## **6.6 Permit Processing/Public Comment/Post Public Notice Addendum**

The draft NPDES permit for the ArcelorMittal Indiana Harbor, LLC – Central Wastewater Treatment Plant was made available for public comment from August 15, 2011, through September 30, 2011, as part of Public Notice No. 2011-8F-RD/PH. In addition, a public hearing was held in Gary, Indiana, on September 15, 2011. During the comment period and at the public hearing, comments were received concerning the draft permit. Comments received at the hearing and/or submitted via email, and this Office's corresponding responses, are summarized below. Any changes to the permit and/or fact sheet are so noted below.

#### Dissolved Metals Translators

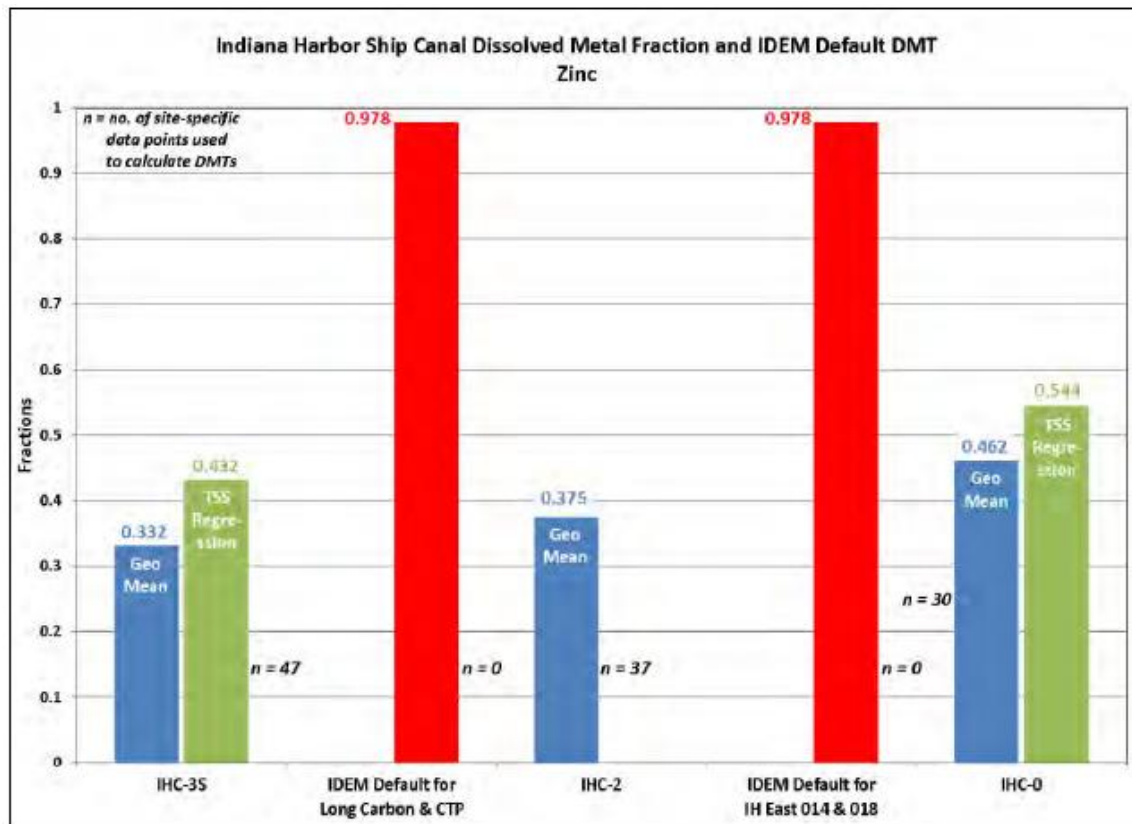
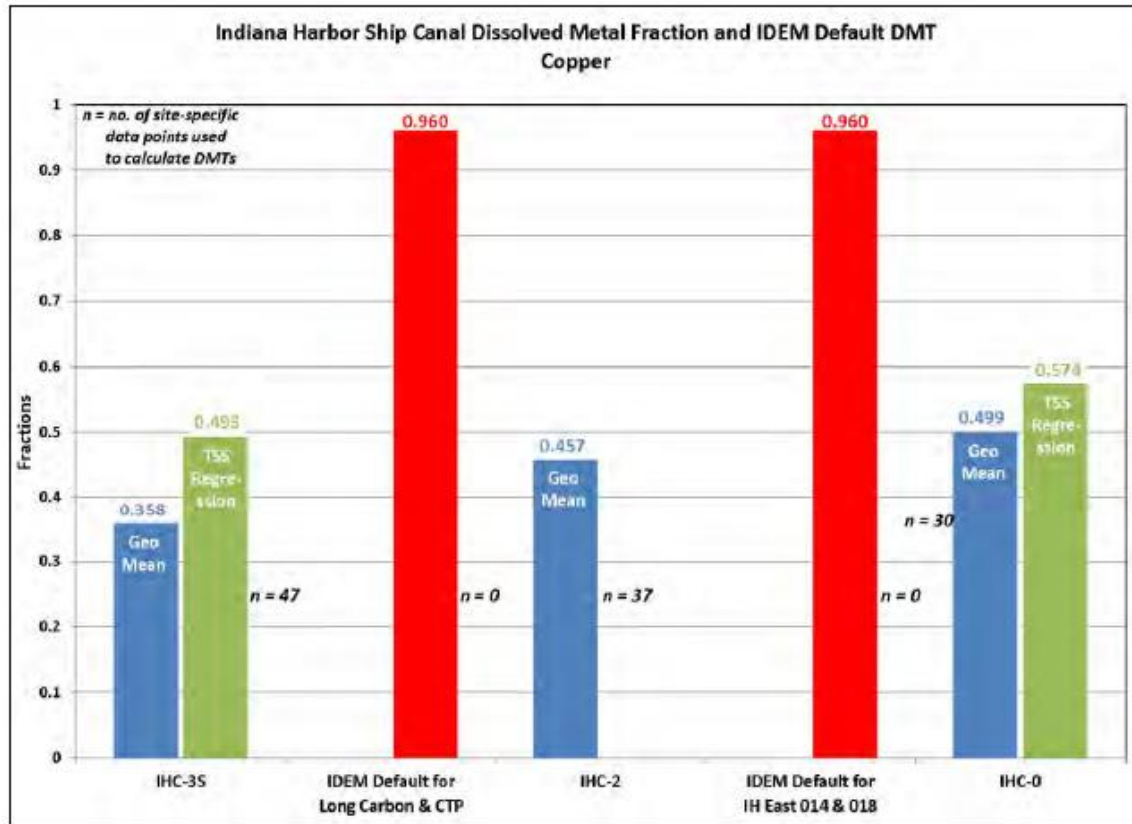
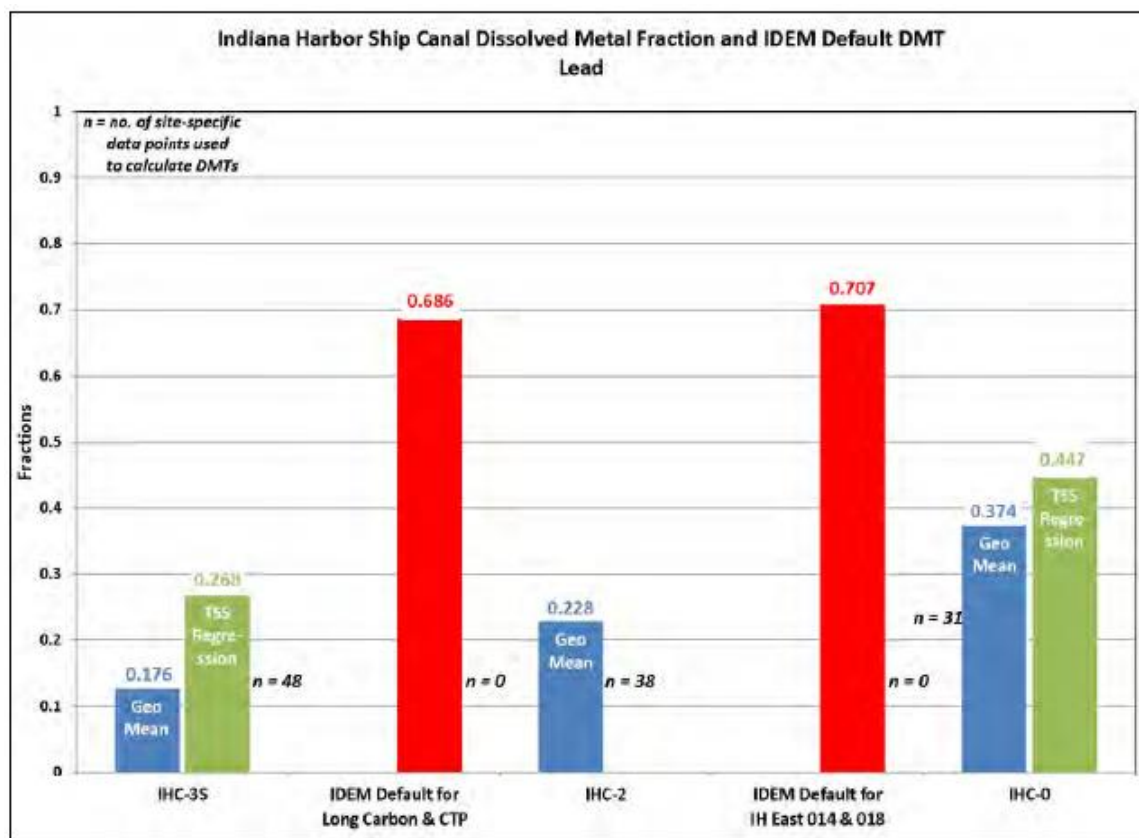
Total and dissolved data for copper, lead and zinc collected by IDEM from the Indiana Harbor Ship Canal at fixed monitoring stations IHC-2 (Dickey Road) and IHC-0 should be used to calculate site-specific dissolved metals translators (DMTs). These DMTs should be used in the calculation of preliminary water-quality based effluent limits for the Central Treatment Plant (CTP) Outfall 001, and Indiana Harbor East Outfall 014. Data collected by IDEM over a period of several years for these metals demonstrate that the majority of the copper, lead and zinc present is associated with particulate in the water column and is not in the dissolved form. Dissolved metals more closely approximate the bioavailable fraction in the water column than do total or total recoverable metals. Consequently, use of site-specific DMTs is well suited for the IHSC. The Dickey Road fixed monitoring station, located downstream of CTP Outfall 001, serves as an appropriate data set for calculating DMTs for development of QBELs for CTP Outfall 001. IDEM should consider the Dickey Road data representative of conditions in the IHSC and reliable because IDEM used the lead and zinc data collected at Dickey Road for another purpose in the NPDES permit renewal process for the ArcelorMittal facilities (*i.e.*, Dickey Road data were used to project the effluent quality from Indiana Harbor West Outfall 007 in IDEM’s multi-discharger WLA). The IHC-0 fixed monitoring station is located downstream of Indiana Harbor East Outfall 014.

Per EPA guidance<sup>2</sup>, DMTs can be calculated as the dissolved to total metal fraction, and can be calculated from a correlation of the dissolved fraction to receiving stream TSS concentration. Following that guidance, DMTs for copper, lead and zinc were calculated from the Dickey Road and IHC-0 data and are summarized below. The dissolved and total metals data used in the DMT calculations are attached (see Attachment IHC-1). For comparison, IDEM's default translators that were used in the development of the proposed permit limits, and DMT's calculated from data collected by IDEM at fixed Station IHC-3S are also shown.

IDEM's default DMTs, which rely on no data specific to the IHSC, are clearly inaccurate for the ArcelorMittal permits and overestimate the dissolved copper, lead and zinc fractions in the IHSC by significant amounts. For example, the default translators are 2.1, 3.0 and 2.6 times greater than the calculated geometric mean of the dissolved fractions for copper, lead and zinc, respectively, at IHC-2. Even the 95<sup>th</sup> percentiles of the dissolved fractions for all metals at all locations are significantly below IDEM's default translators. As shown, the DMTs calculated at IHC-3S, IHC-2 and IHC-0 are considerably lower than IDEM's default DMTs used in the calculation of WQBELs. Graphs of the geometric mean dissolved fractions, TSS-regression developed DMTs, and IDEM's default DMTs are presented below.

Given the data presented in the table and graphs above, it is not reasonable to assume, as IDEM has done through use of the default DMTs, that the dissolved metal fraction in the water column somehow increases dramatically in between the fixed monitoring stations. ArcelorMittal's requested effluent limits, based upon site-specific DMTs derived from the IDEM fixed monitoring station data and other factors, are presented below.

As noted in a prior response, IDEM does not believe it is acceptable to re-establish background at Dickey Road and has not received a site-specific metals translator study so the current multi-discharger model was not revised. IDEM did look at the impact of lowering the ArcelorMittal Long Carbon allocation, as requested, and did not find a significant impact on the calculation of downstream WQBELs. For future wasteload allocation considerations, a site-specific metals translator along with more refined effluent concentration characteristics will provide the greatest means of showing that more assimilative capacity is available than currently modeled.
